U.S. Department
of Transportation
**Federal Aviation
Administration**

Addendum

April 1, 2025

RE: Addendum to the Endangered Species Act Section 7 Conference and Biological Opinion on SpaceX Starship-Super Heavy Increased Launch Cadence and Operations in the North Atlantic Ocean, Gulf of America, North Pacific Ocean, South Pacific Ocean, and Indian Ocean Authorized by the Federal Aviation Administration

Figure 1. Comparison of Previous and Revised Gulf of America Landing Area

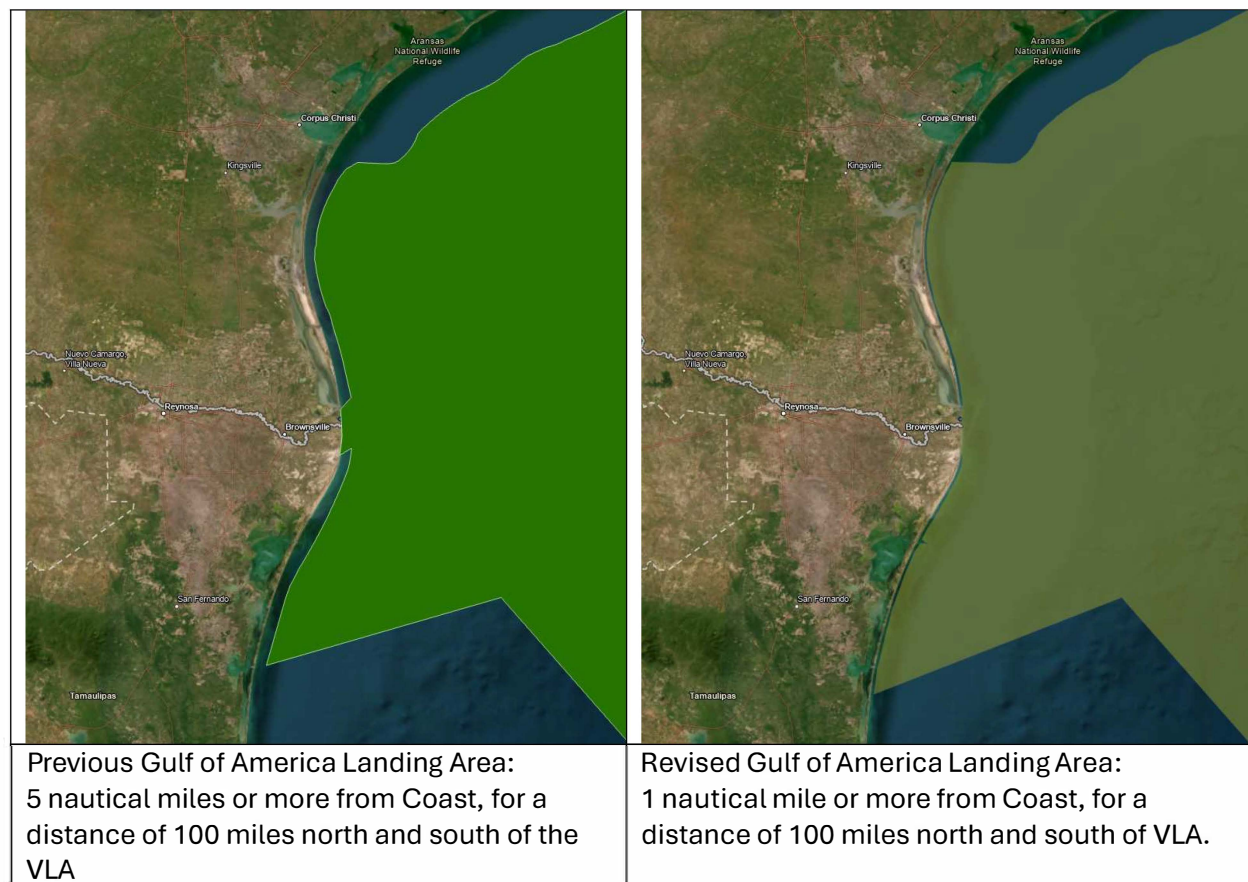
- Revised the Gulf of America Landing Area in the proposed action area to include Starship landings (including potential overpressure events) in the Gulf of Mexico.

- Expanding the Gulf Action Area to 1 nautical mile or more from shore for a distance of 100 miles north and 100 miles south of Boca Chica. Figure 1 has been revised to reflect the change to the Gulf of America action area.

Figure 2. Comparison of Previous and Revised Atlantic Ocean Action Area

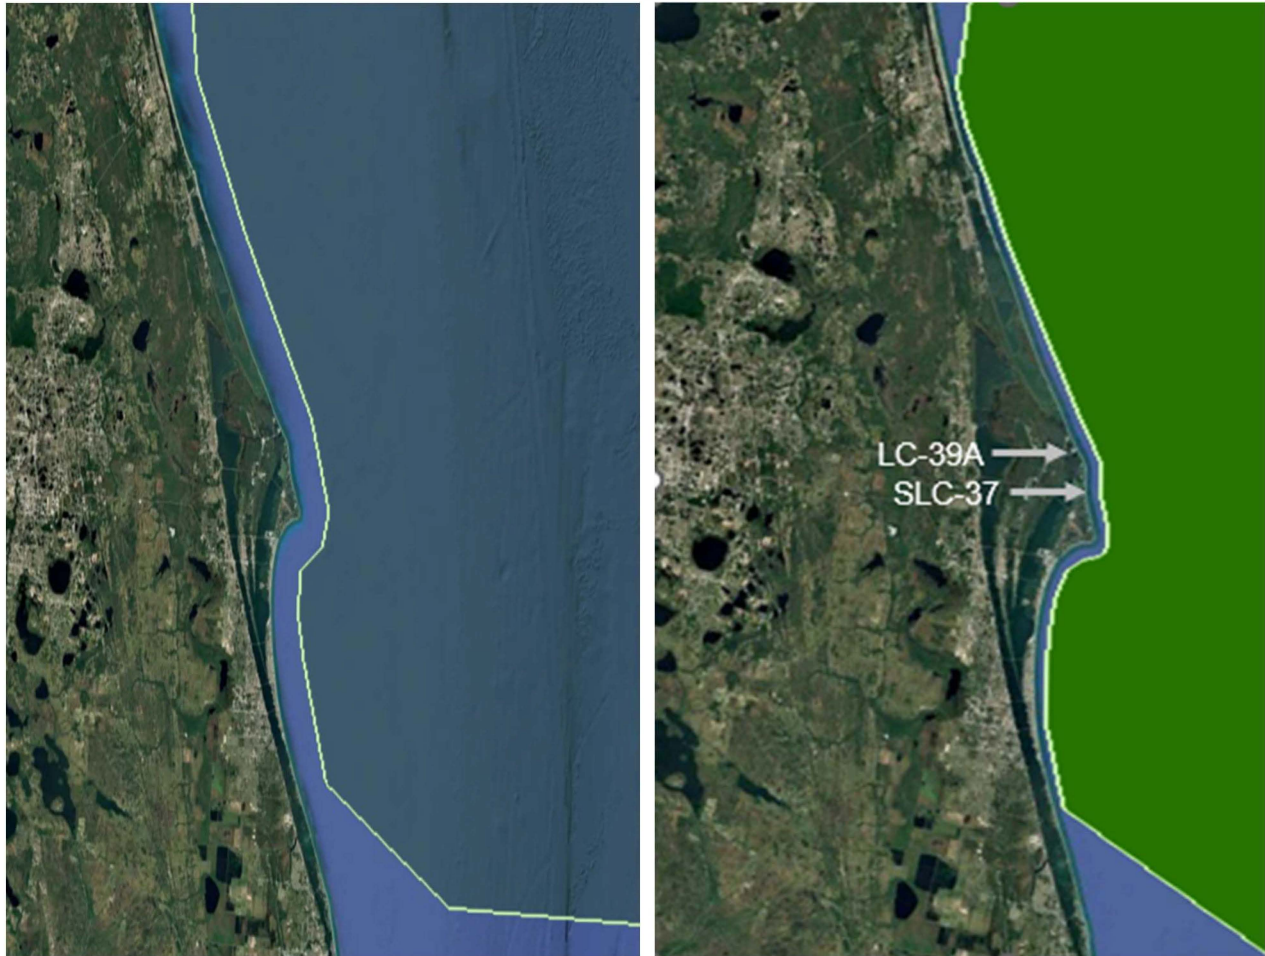
- Expanded the Atlantic Ocean Action Area from 5 nautical miles or more to 1 nautical mile or more from shore. This expansion of the action area applies to a distance of 50 miles north and 50 miles south from KSC LC-39A and CCSFS SLC-37 for Starship and Super Heavy landings. Figure 2 has been revised to reflect the change to the Atlantic Ocean Action Area and Figure 3 is the current Atlantic Action Area provided for reference.

Previous Atlantic Ocean Landing Area
5 nautical miles or more from Coast

Revised Atlantic Ocean Landing Area
1 nautical mile or more from Coast, for a
distance of 50 miles north and south of LC-39A
and SLC-37

Figure 3. NARW Critical Habitat with Previous and Revised Atlantic Ocean Action Area

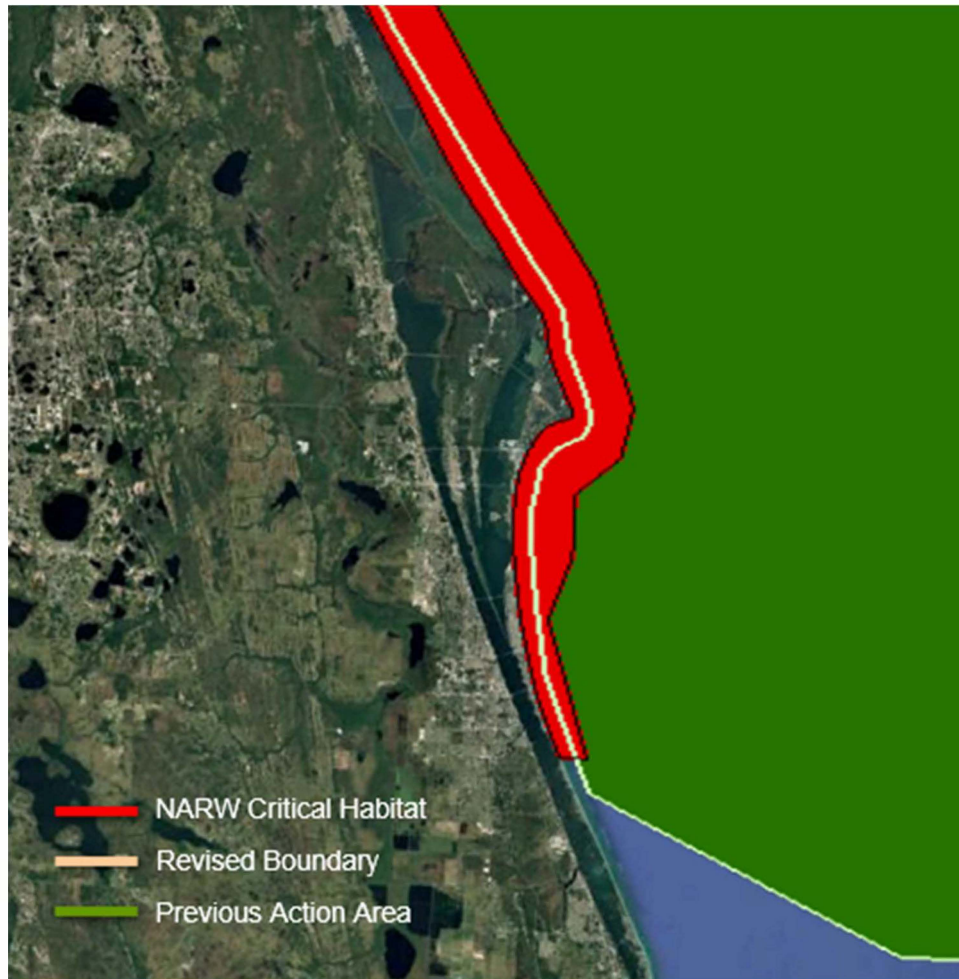
Designated critical habitat for NARW calving occurs within the revised Atlantic Ocean Action Area (shown in red in Figure 3). The yellow line in the figure is the revised boundary, and the green line represents the updated boundary of the action area. The essential physical and biological features for NARW critical calving habitat are: 1) calm sea surface conditions of Force 4 or less on the Beaufort Wind Scale; (2) sea surface temperatures from a minimum of 7 °C, and never more than 17 °C; and (3) water depths of 6 to 28 meters, where these features simultaneously co-occur over contiguous areas of at least 231 nm² of ocean waters during the months of November through April. Landing operations, including potential overpressure events, would only temporarily affect surface
